8TH & COLUMBIA

RECOMMENDATION MEETING | DPD #3013479 | AUGUST 21ST, 2013

EDG GUIDANCE AND APPLICANT RESPONSES

DEPARTURE 4

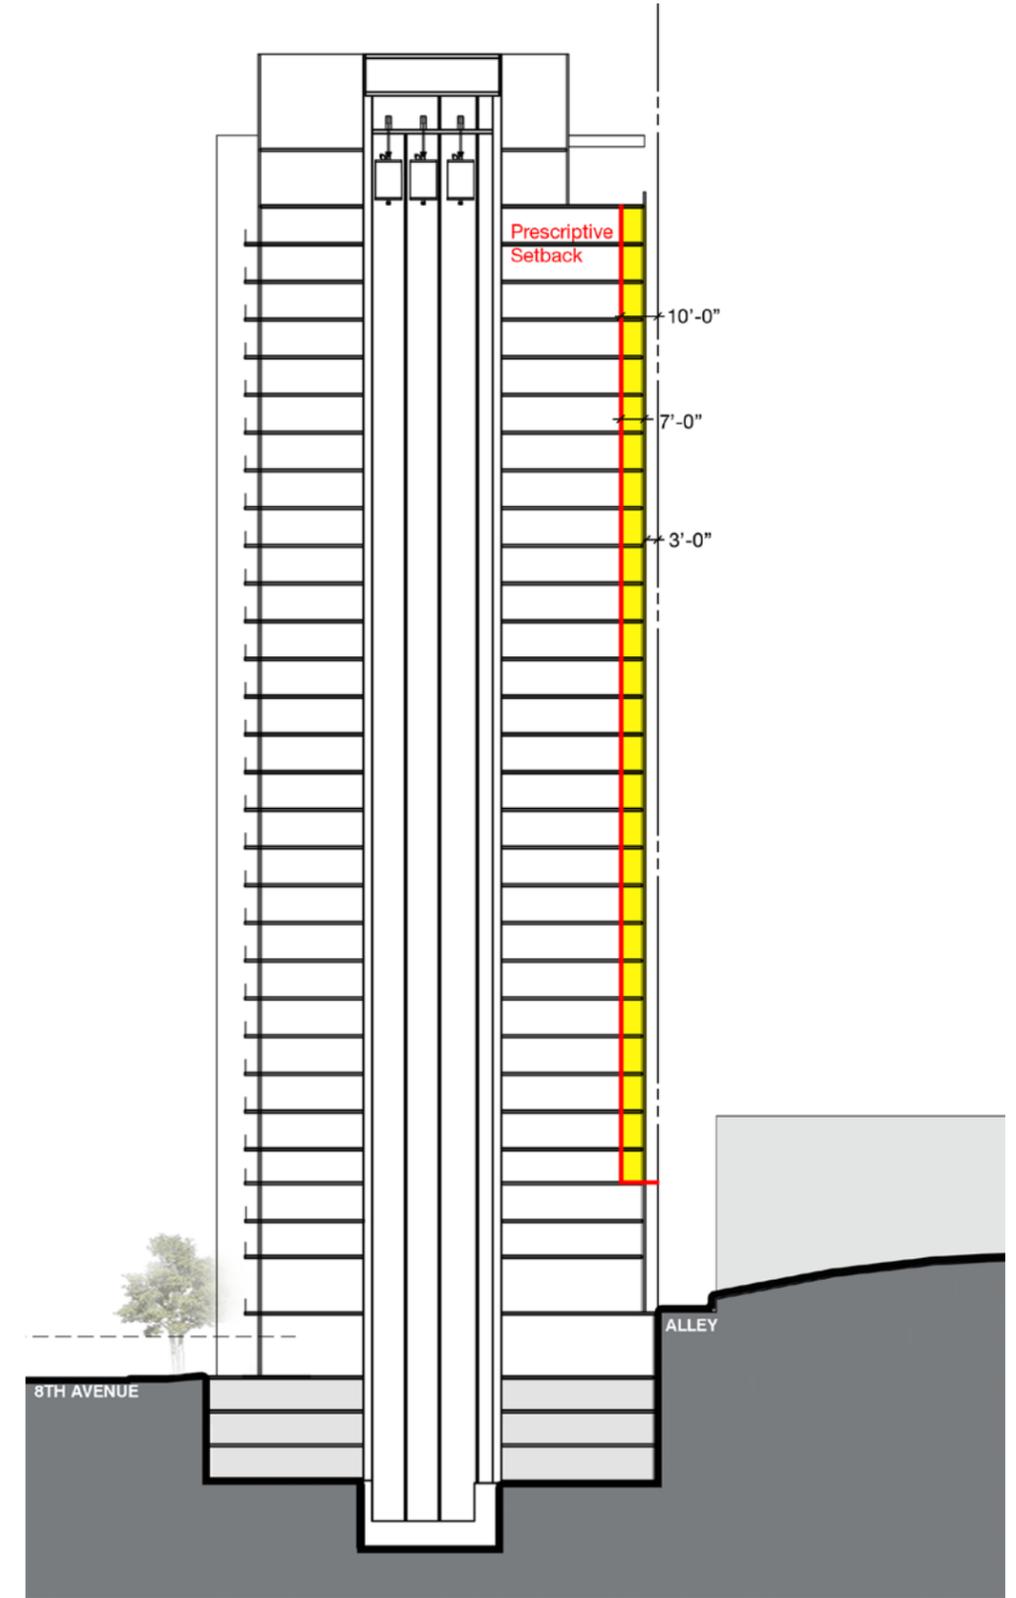
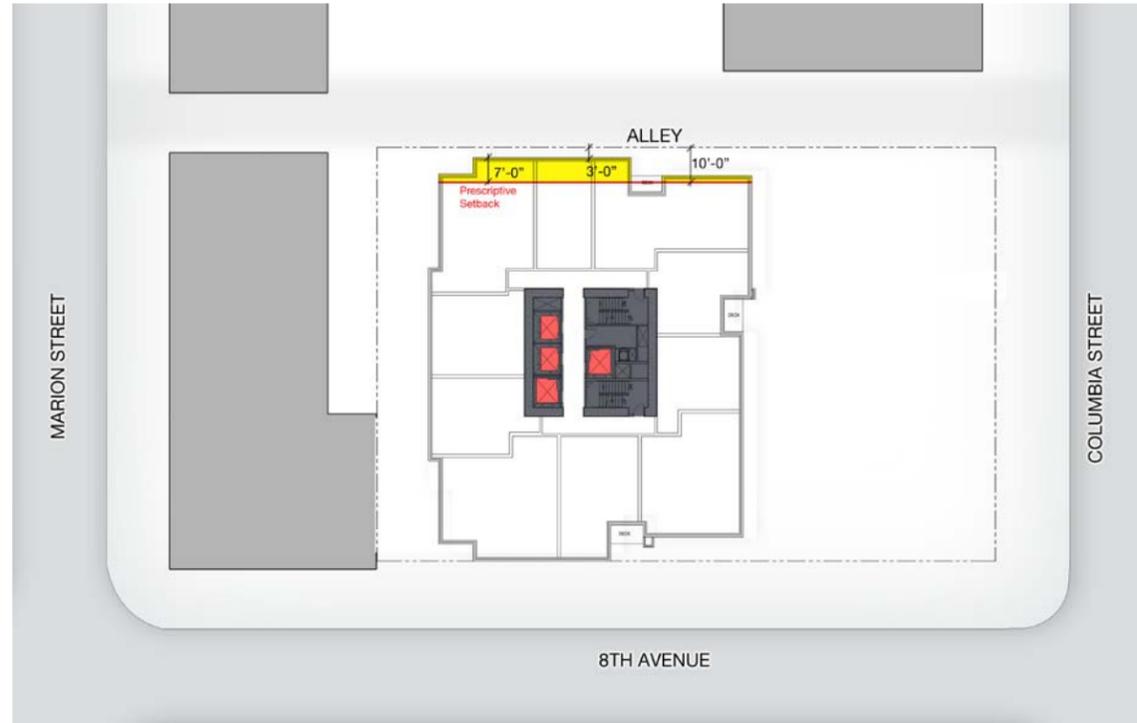
PRESCRIPTIVE At lot lines abutting the alley: Portions above 45': 10' minimum setback

PROPOSED At lot lines abutting the alley: Portions above 45': 3' setback

CONSIDERATIONS Slenderizes the building in the North-South direction. This allows a larger open space on the Southeast corner of the site.

DEPARTURE 5

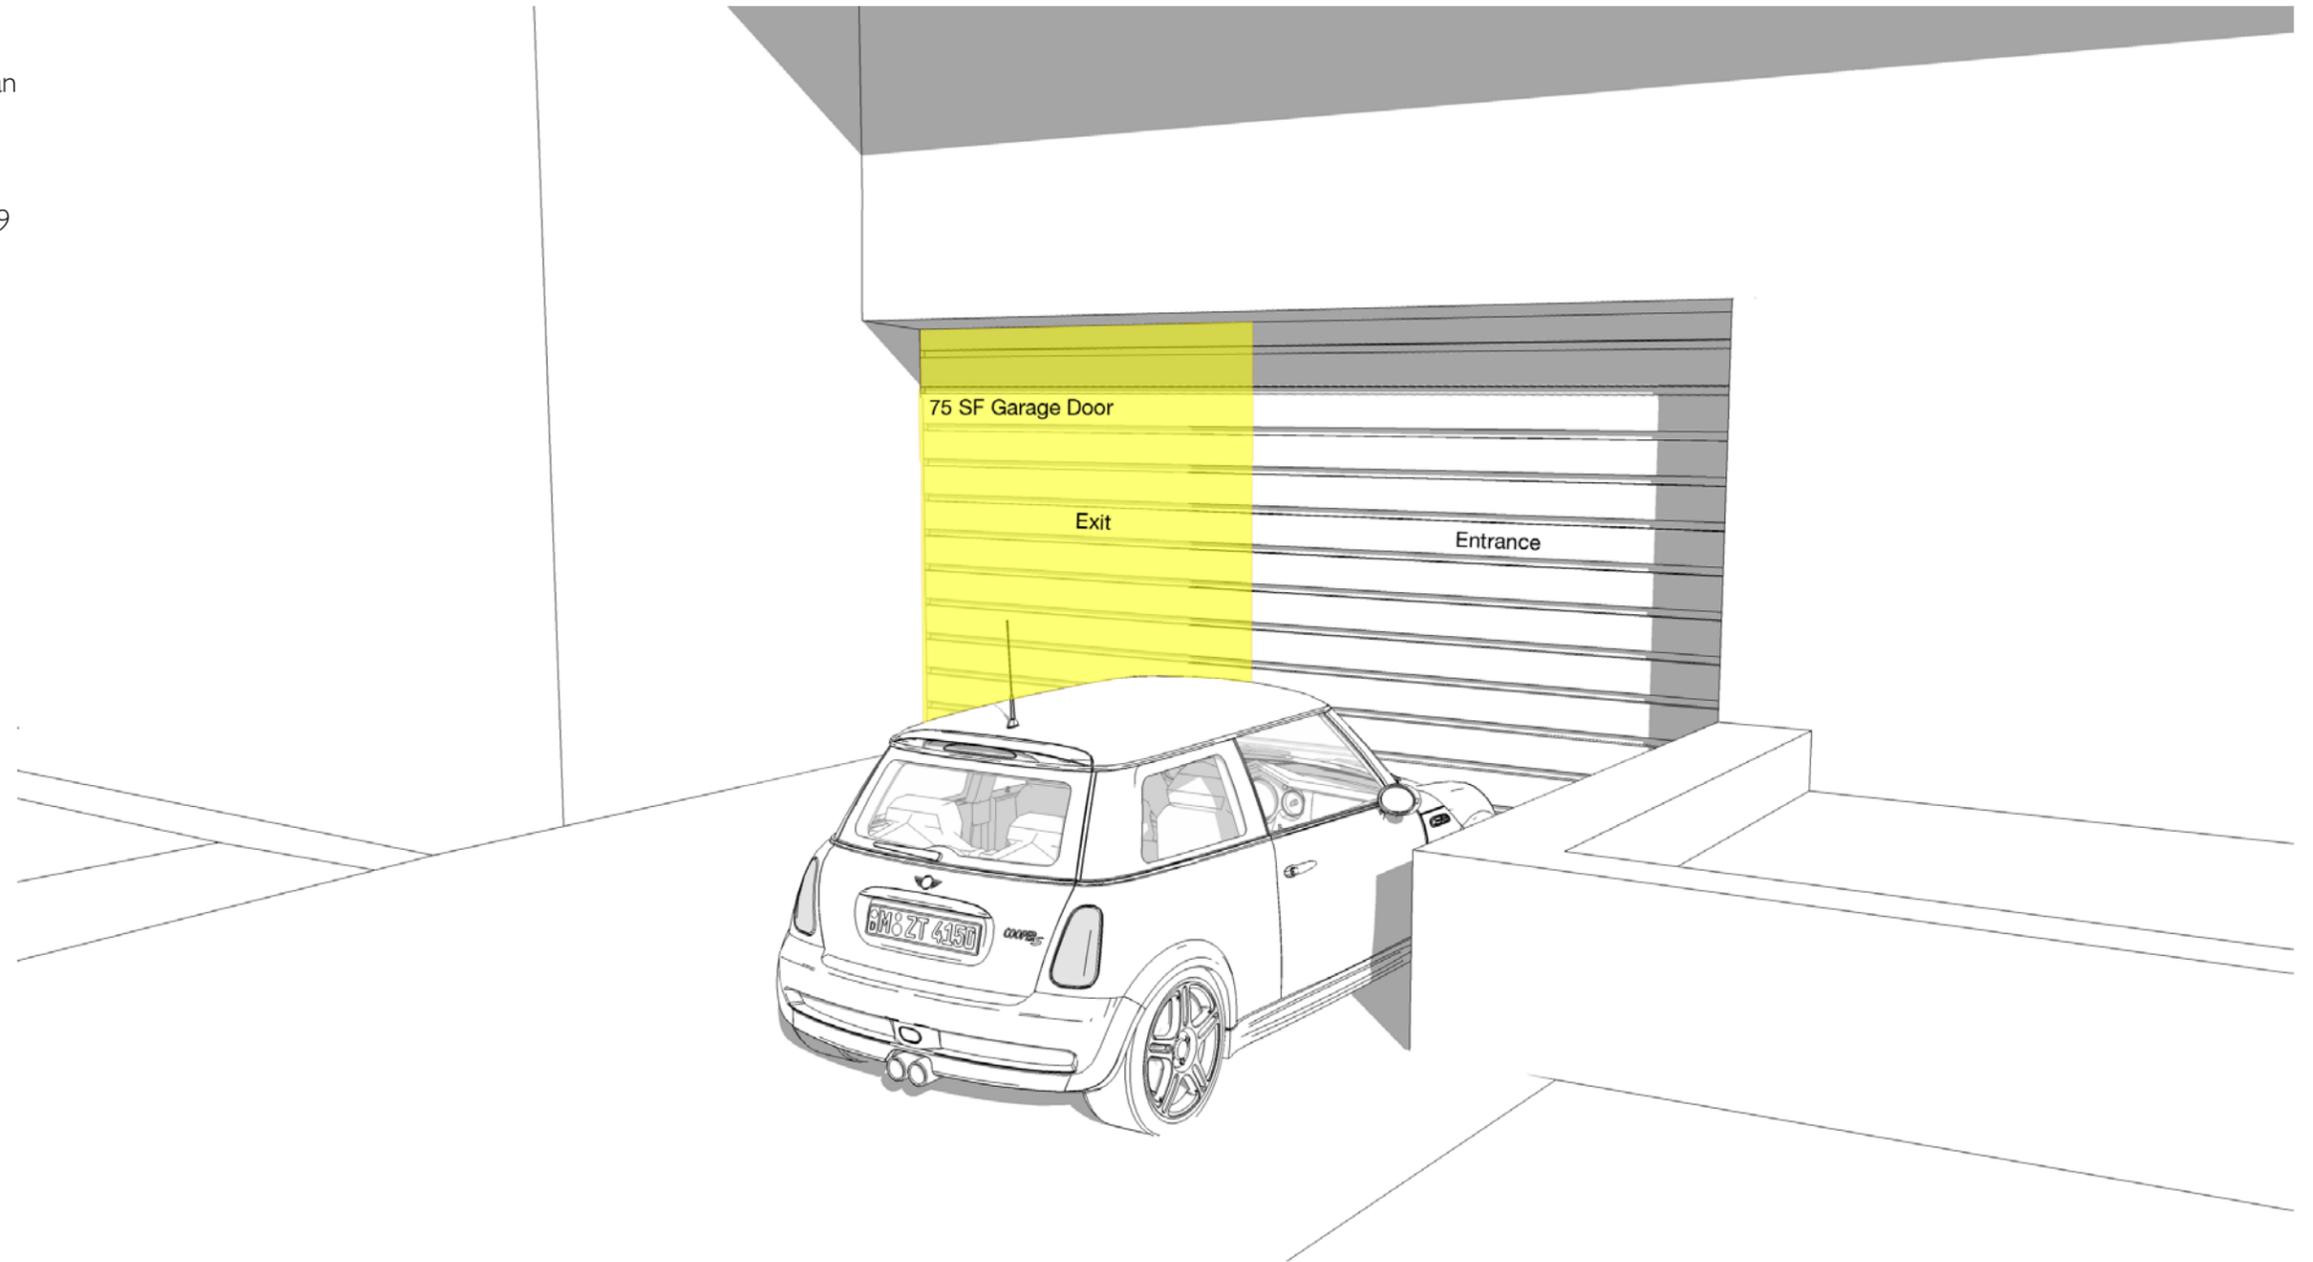
PRESCRIPTIVE Garage doors may be no more than 75 square feet in area.

PROPOSED Garage door is proposed to be 189 square feet in area.

CONSIDERATIONS To allow for the required two-way traffic into the garage; the door is required to be 20 feet in width.
